Asbestos Abatement Scope of Work

Purpose: Abatement Prior To 2021 Renovation

Dayton Grade School - Two Phases March Start / June Start
526 Ferry Street
Dayton, Oregon 97114

ADDENDUM 2

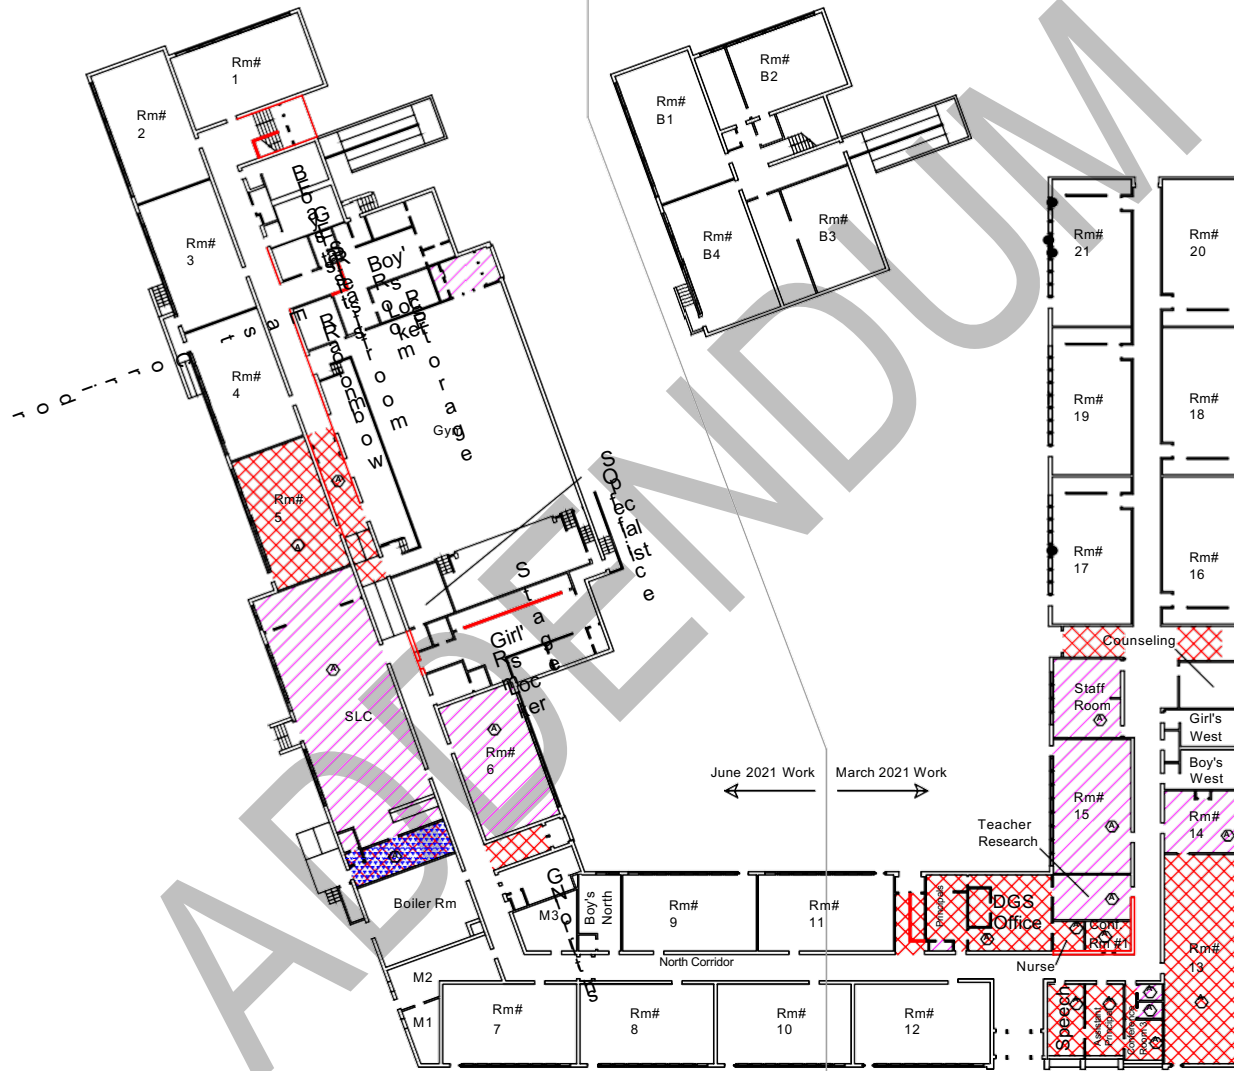
-  Remove and dispose of single layer AC floor tile and AC mastic - 5,645 sq. ft.
This material is on concrete.
-  Remove and dispose of carpet and AC floor tile and mastic - 5,140 sq. ft.
This material is on concrete.
-  Remove and dispose of drywall ceiling with AC joint compound - 305 sq. ft.
-  Remove and dispose of drywall and AC joint compound - 3,445 sq. ft.

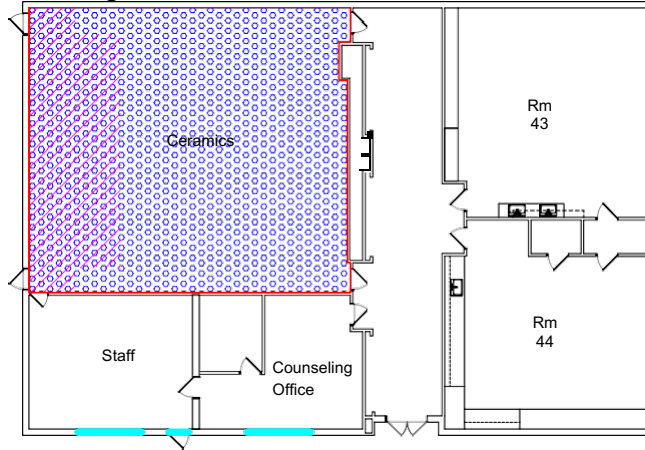
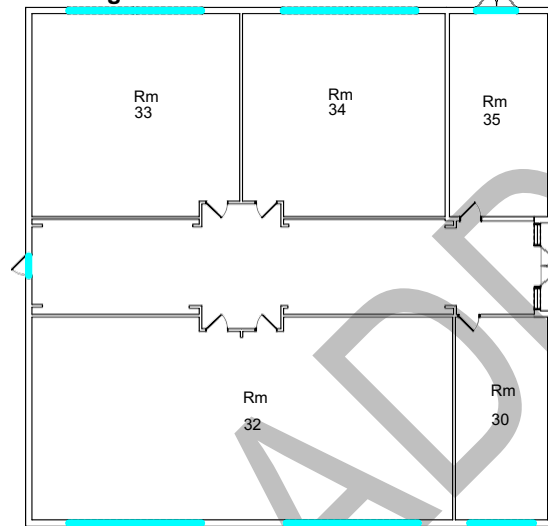
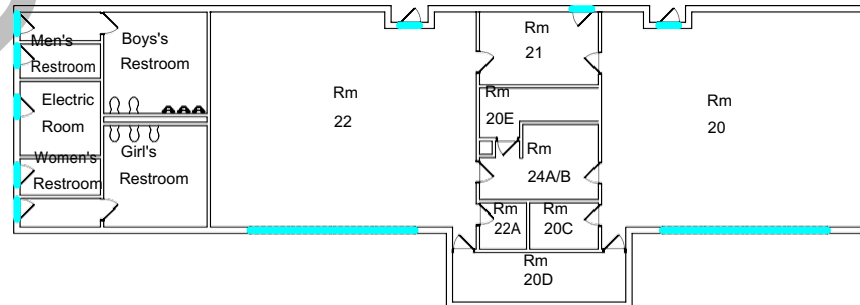
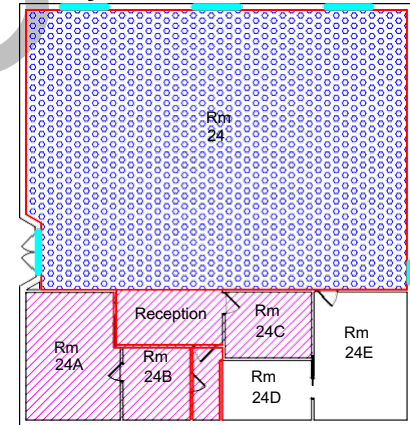
- Remove and dispose of AC suspended ceiling tile (Grid to remain) - 3,240 sq. ft.
- Remove and dispose of AC floor tile and AC mastic - 955 sq. ft.
- This material is on concrete.
- Remove and dispose of drywall and AC joint compound - 3,000 sq. ft.
- Remove and dispose of CAB/window assembly, including all caulking and sealants.
